Modification 2 Application

Walla Walla Solar Farm

March 2022

Project Number: 21-200

Figure 5-1 Proposed Modification

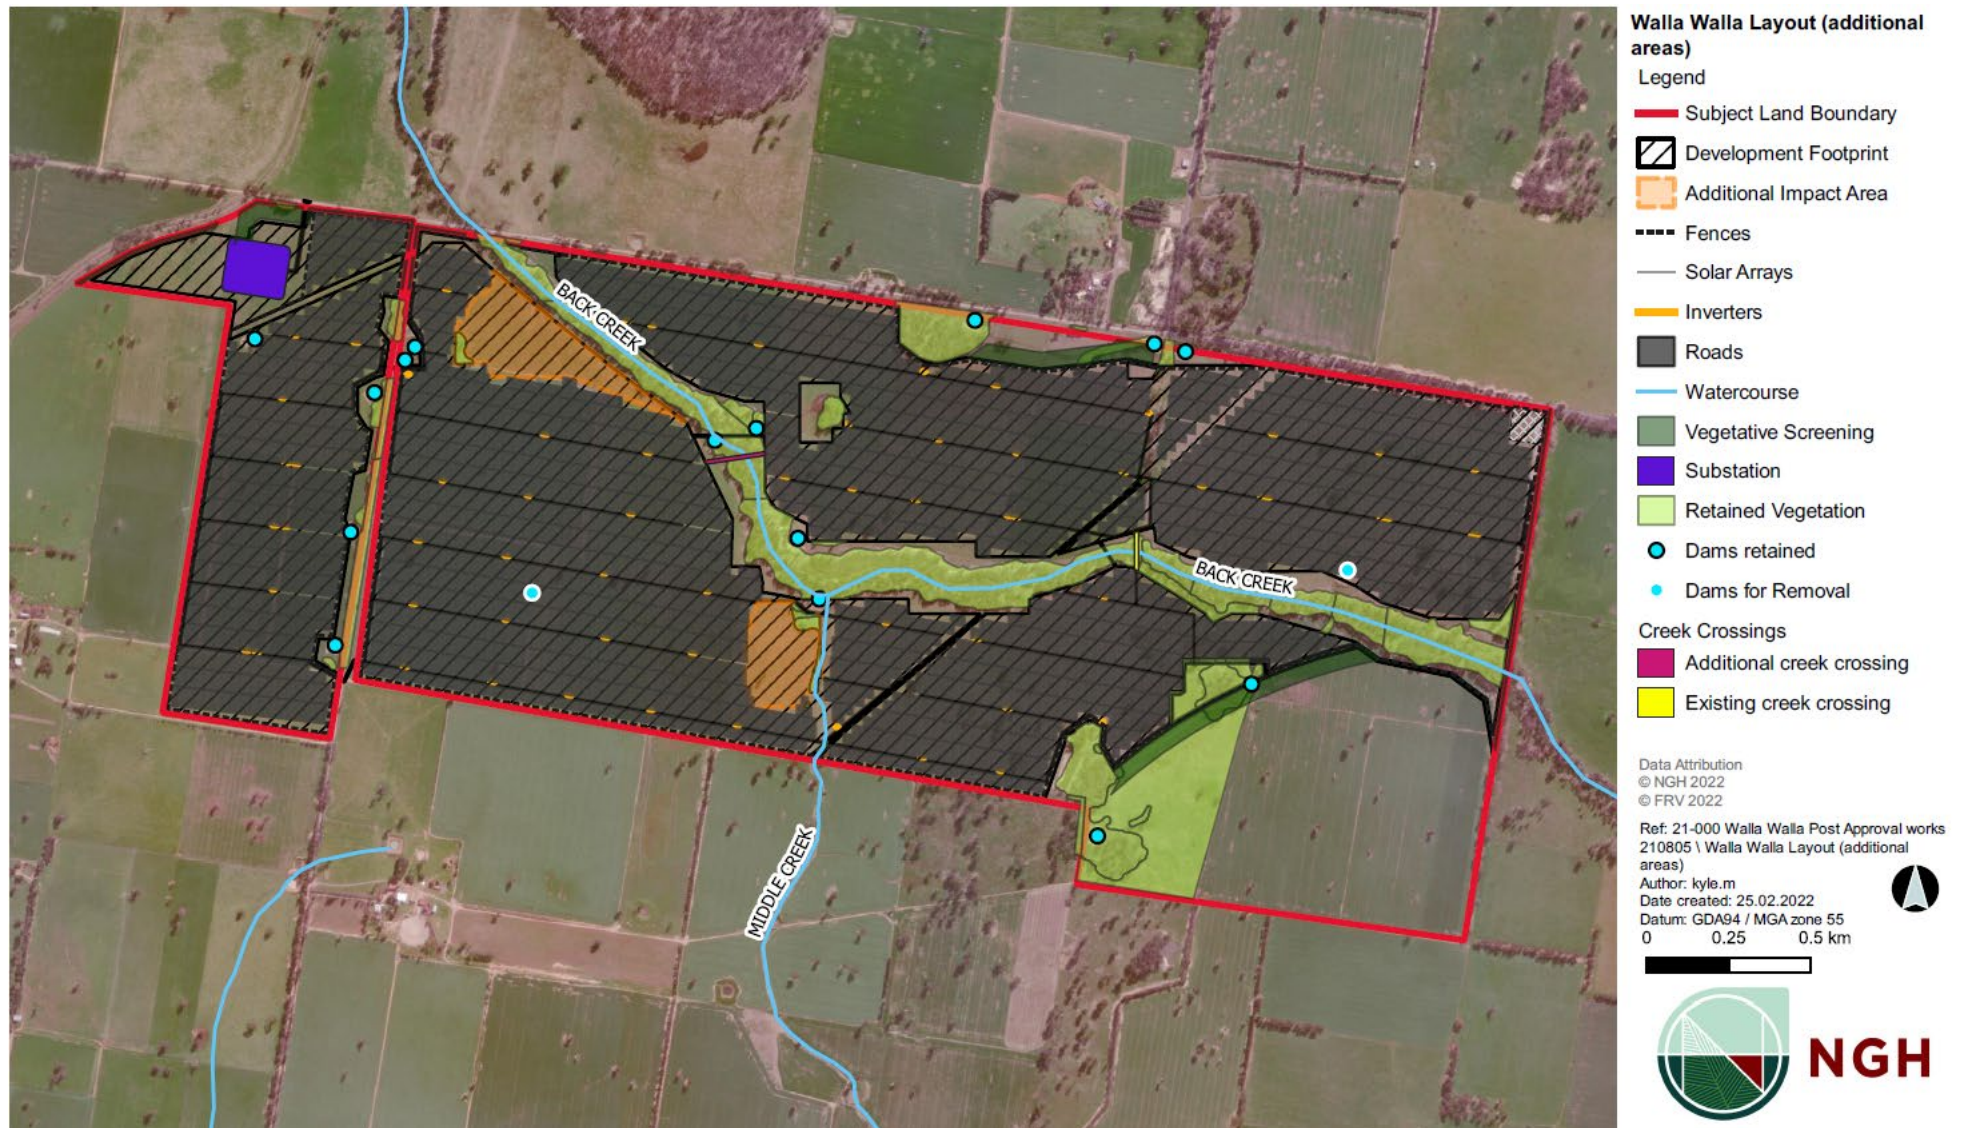
The proposed amendment to the Project Development Footprint and increased solar array is shown in Figure 5-1.

The additional development footprint area is approximately 15.7 ha and will be used to increase the solar array with the following infrastructure:

- An additional approximately 50,000 PV solar arrays mounted on single axis tracking systems.
- No additional modular inverter units.
- Associated internal reticulation, access and ancillary infrastructure.
- Additional upgraded creek crossing.

Figure 6-1. Proposed new Aboriginal cultural heritage impacts and investigation areas within the Walla Walla Solar Farm

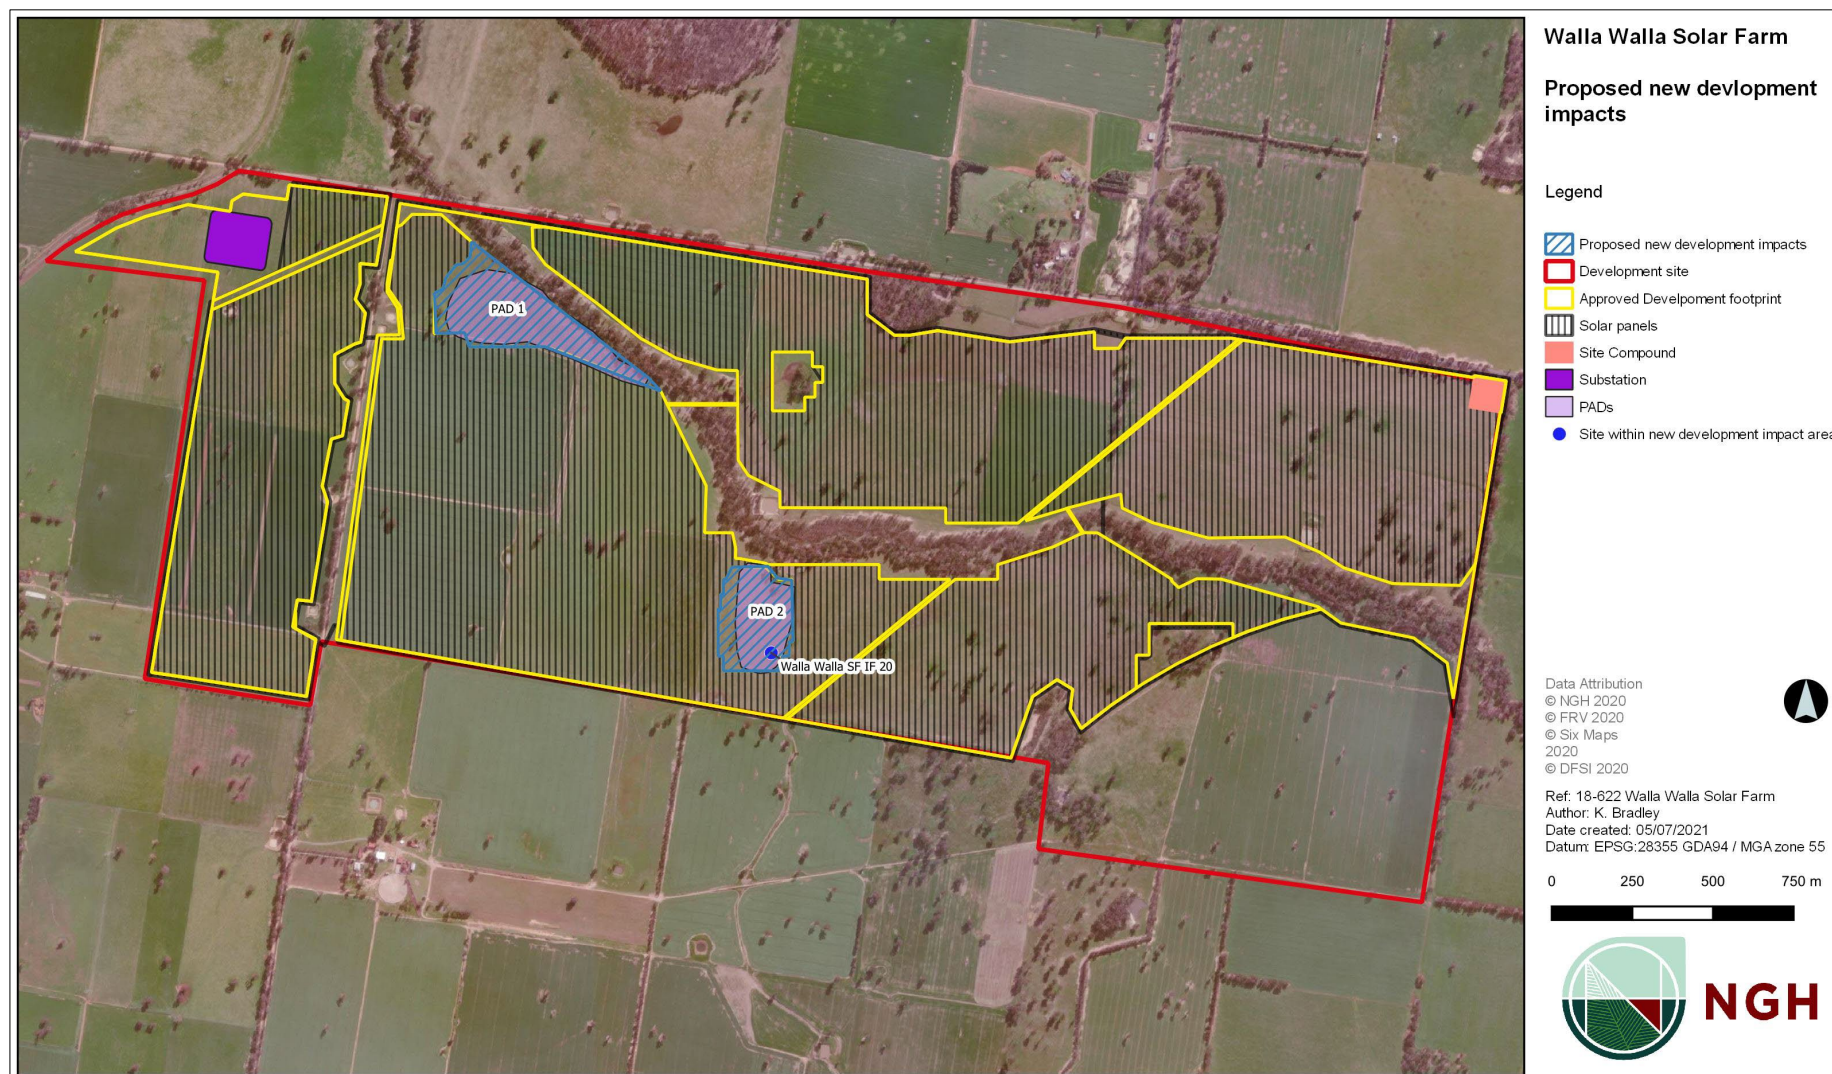
Whilst there would be no change to the project's site boundary, the modification would increase the project's development footprint by 15.7 ha. This increase would impact previously avoided areas of

Walla Walla PAD 1, Walla Walla PAD 2 and the site Walla Walla SF IF 20. The location of the impacted Aboriginal sites within the development footprint are shown in Figure 6-1.

Figure 6-4 Final project footprint in relation to vegetation

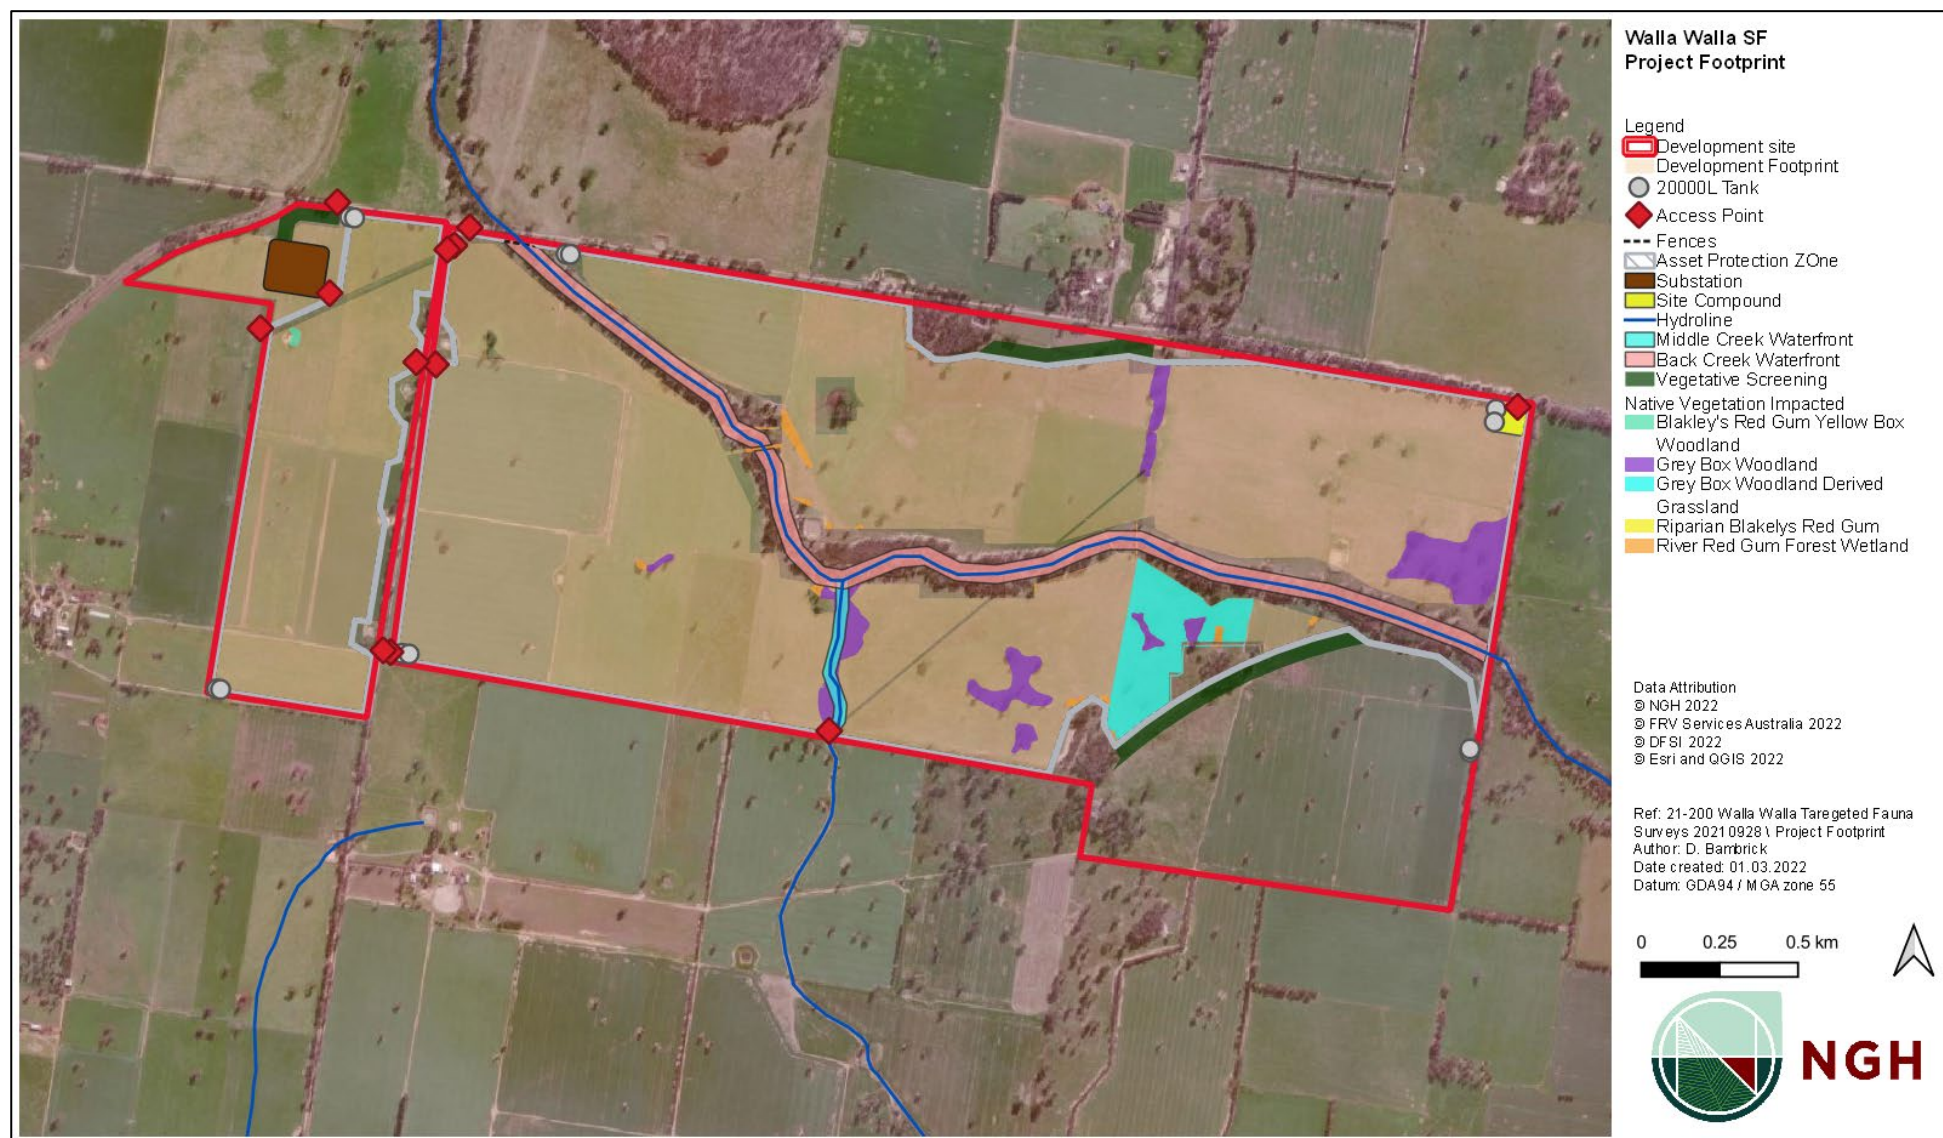
The modification proposes the development of a total additional area of 16.6 ha within the Project Site. The final Project layout in relation to vegetation communities is shown in Figure 6-4. This additional area has largely avoided native vegetation zones within the site. One scattered tree will require removal.
